**PARK CITY HISTORIC PRESERVATION BOARD MEETING
SUMMIT COUNTY, UTAH
May 1, 2024**

**PARK CITY MUNICIPAL CORPORATION
HISTORIC PRESERVATION BOARD MEETING
MARSAC MUNICIPAL BUILDING
COUNCIL CHAMBERS
445 MARSAC AVENUE
PARK CITY, SUMMIT COUNTY, UTAH
MINUTES OF APRIL 3, 2024**

B. Land Management Code Amendment – Historic District Regulation Illustrations – The Historic Preservation Board will Review Draft Illustrations of the Historic District Requirements and Provide Feedback to Staff. PL-23-06002.

Subject: 81 Daly Avenue
Application: PL-23-05683
Author: Caitlyn Tubbs, Senior Planner
Date: May 1, 2024
Type of Item: Work Session – Reconstruction and Relocation

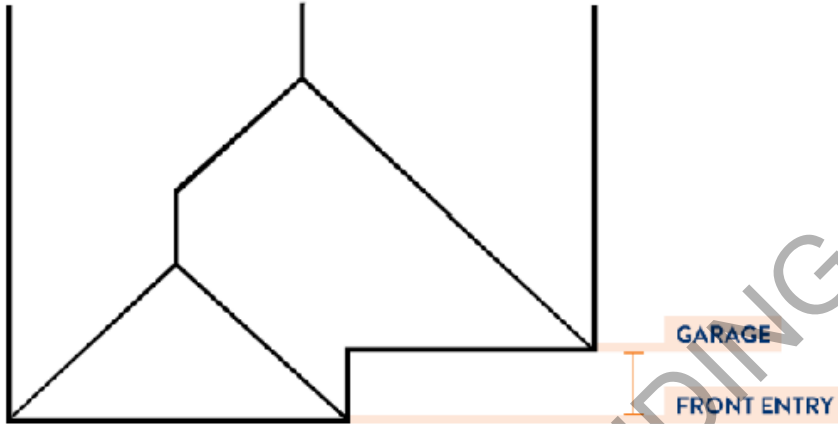
The second requirement stated that “Windows with vertical elements are encouraged. The general rule is the height shall be twice the dimension of the width (commonly referred to as a 2:1 ratio). Double-hung, vertically proportioned windows similar to those used historically are particularly encouraged. Windows with traditional depth and trim are preferred.” Planner Tubbs noted that the illustration was of a window that was twice as tall as it is wide. Board Member Stephens was unable to see the vertical casing trim going down each side. He thought that element needed to be added to the illustration.

Garages featuring a side-by-side parking configuration shall maintain a 2 foot horizontal offset in the front wall plane.

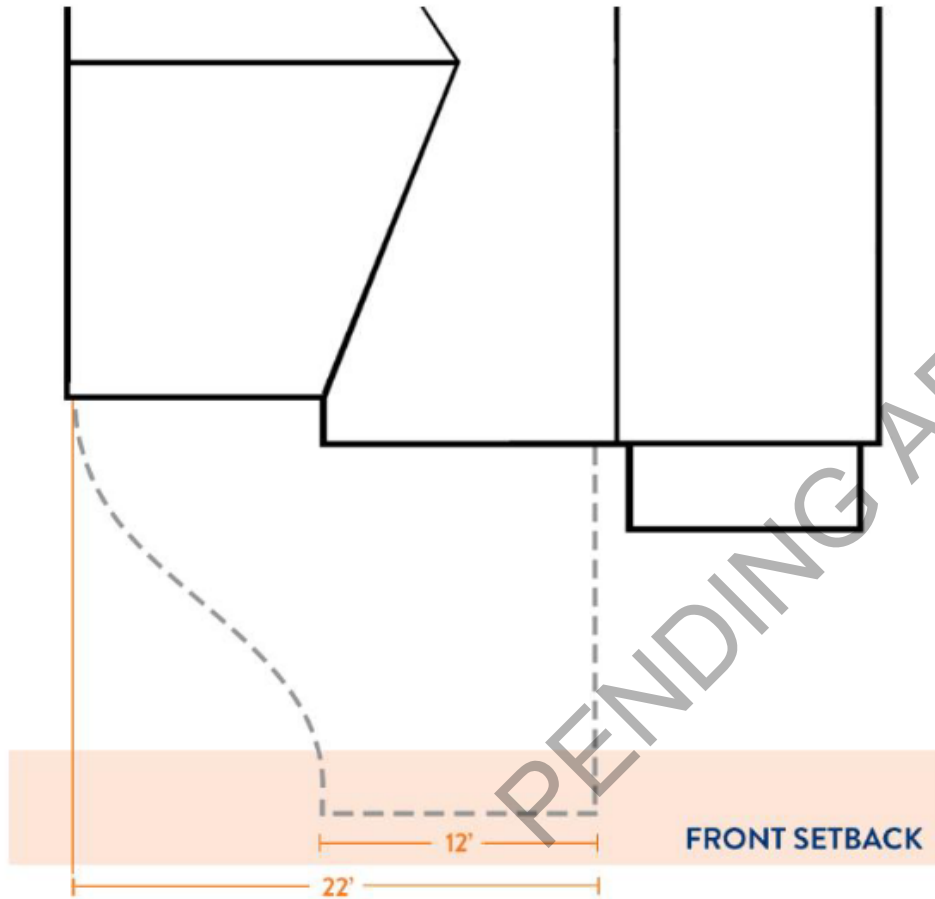
The next requirement stated that “Garages featuring a side-by-side parking configuration shall maintain a 2-foot horizontal offset in the front wall plane.” Planner Tubbs explained that the requirement is there to make sure that there is not just one large wall of garage at the street front. She pointed out the front entry and garage on the proposed illustration. Board Member Stephens suggested that those elements be clearer on the illustration. He also felt that the scale of the illustration was off and asked that it be looked at again.

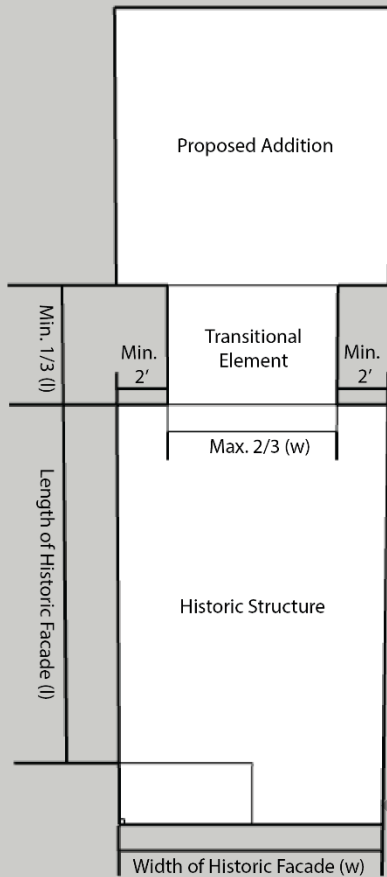
The next requirement stated that “A site shall be returned to original grade following construction of a foundation. When the original grade cannot be achieved, no more than eight inches of new foundation shall be visible above final grade on the primary façade. No more than two feet of the new foundation shall be visible above final grade on secondary and tertiary facades.” Planner Tubbs explained that the illustration demonstrates where the two feet would be measured. Board Member Stephens thought there needed to be additional clarity about the location of the primary façade. Board Member Hodgkins felt there needed to be a better illustration to show the siding versus the foundation. Board Member Stephens agreed that more clarity is needed.

Planner Tubbs believed the request is to define where the front is, demonstrate the eight inches on the front, and also clarify the side view. That was confirmed. Board Member Hodgkins suggested a three-dimensional drawing, so it is possible to see the side and front of the building in one illustration. Planner Tubbs noted that there could be two sets of drawings next to one another or there could be a three-dimensional view.

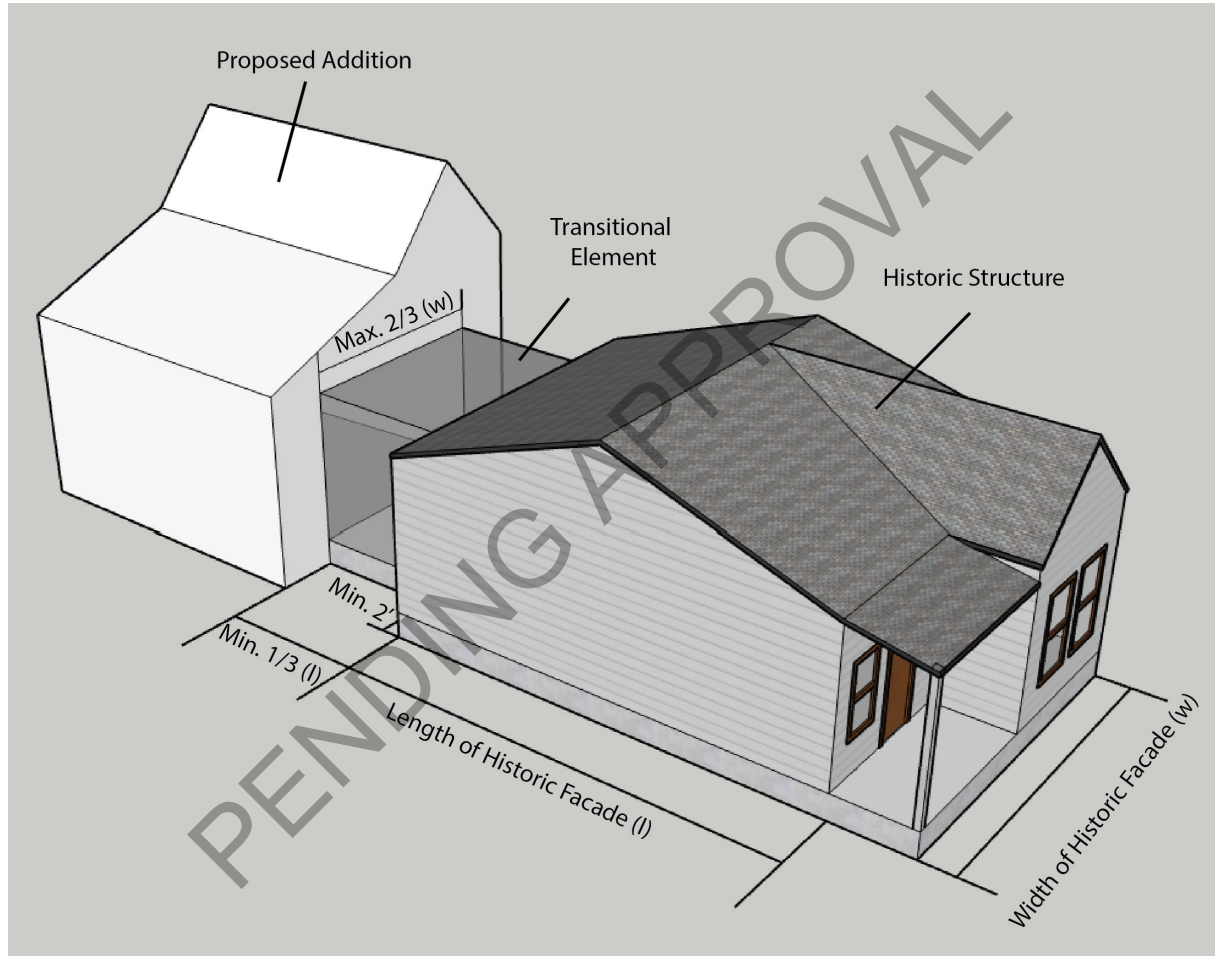
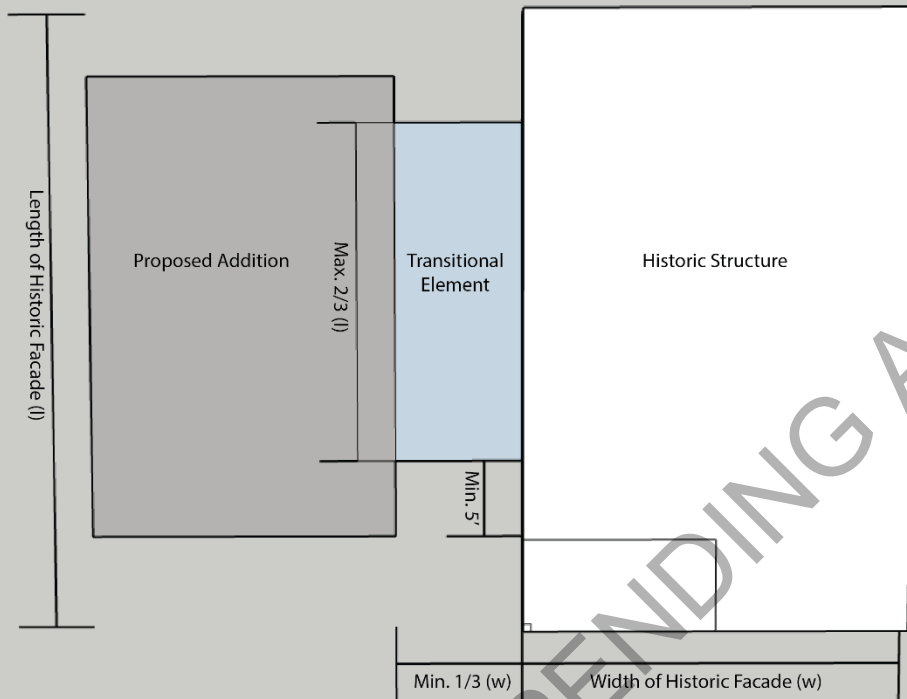
Planner Tubbs reviewed the proposed illustrations. Board Member Hodgkins pointed out that certain elements looked too similar. It was noted that it is possible to put in some graph lines to differentiate things. Planner Tubbs shared the isometric view of the rear addition and read the following language: "In the case of additions to the secondary façade, visible from the primary public right-of-way, the transitional element shall be set back a minimum of five feet from the primary façade." The depth of the transitional element versus the length of the least wide historic elevation is also considered as well as the requirement for rear additions, which is mirrored for side additions with regard to the width. Board Member Hodgkins asked about the line on the lower lefthand corner of the illustration shown. Planner Tubbs explained that it was supposed to indicate a porch. Discussions were had about how to best define the porch area and add additional clarity.

Board Member Hodgkins asked if an addition on the side can be taller than the main structure. Planner Tubbs reported that there is a zone height maximum, but as long as the transitional element is lower than the ridgeline of the historic house, it could be taller.

- (7) The highest point of the transitional element shall be a minimum of two feet (2') lower than the highest ridgeline of the historic structure.

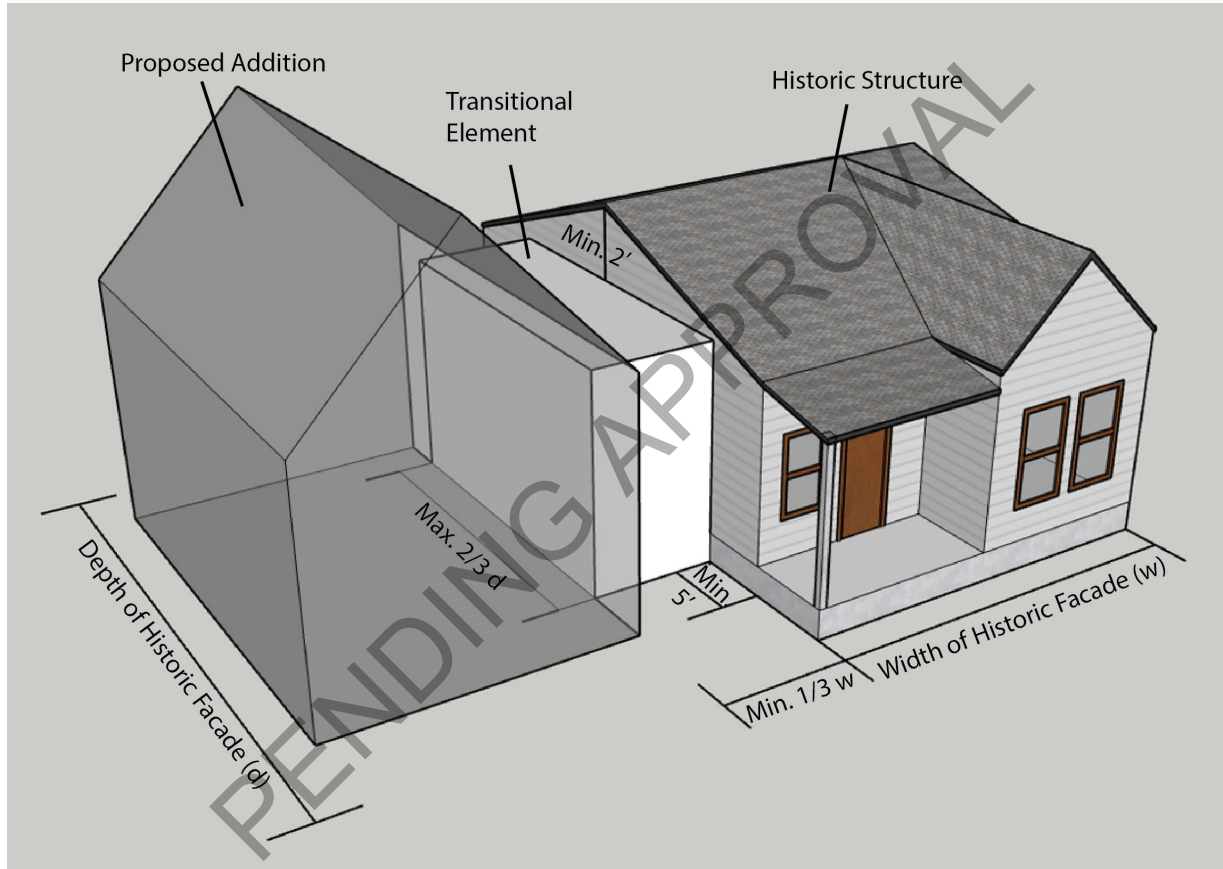
Planner Tubbs shared an additional illustration with the Board. She explained that it related to maximum heights. Board Member Hodgkins asked about the 10-foot minimum setback from the upper street and lower street. Planner Tubbs explained that it was for new construction. The 10-foot setback is a requirement of the zone building height. A maximum building height from grade to the ridgeline is allowed. As part of the height requirement, there is also a minimum setback required from the downhill façade at a maximum of 23 feet. There was a desire to add more clarity to the illustration proposed. It was suggested that the drawing be two-dimensional instead of three-dimensional.
